Nuclear Fuel Services, Inc.
P.O. Box 337, MS 123
Erwin, TN 37650

April 14, 2003

Subject: License Amendment Request Regarding 10 CFR 20.2003 Requirements

Page Changes to SNM-124

Figure 10 16
NFS Inputs to the Sanitary Waste Stream

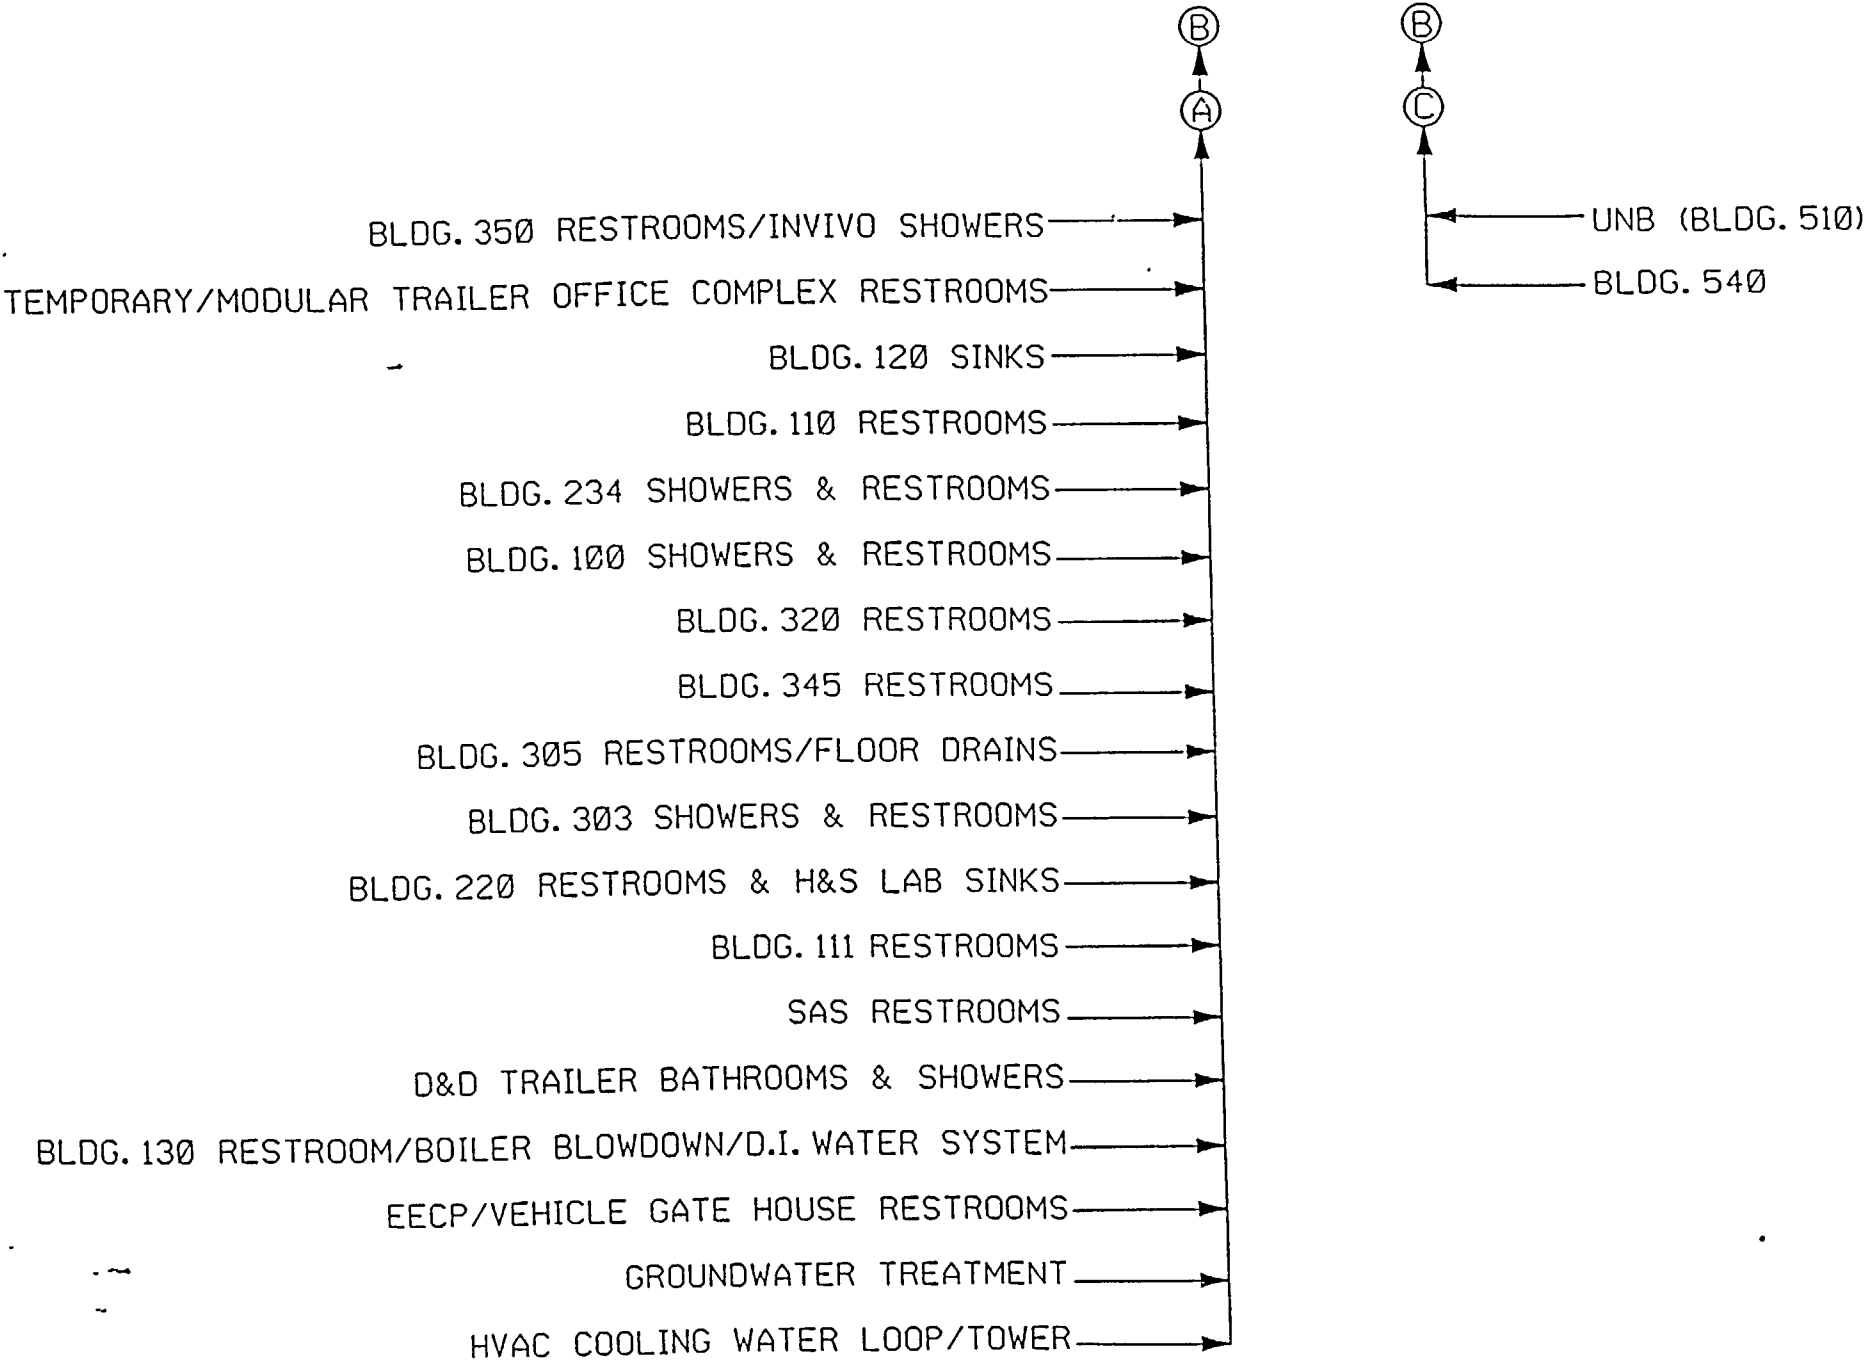
Plant sanitary wastes are discharged through piping which goes to the City of Erwin publicly owned treatment works. The inputs for the sanitary sewer system include all bathrooms and showers (as outlined in Figure 10.16). Water from the Groundwater Treatment Facility is also discharged in accordance with all applicable regulatory requirements. Effluent sampling is addressed in Chapter 5, Section 5.1.2.1 and Chapter 13, Section 13.3.2.
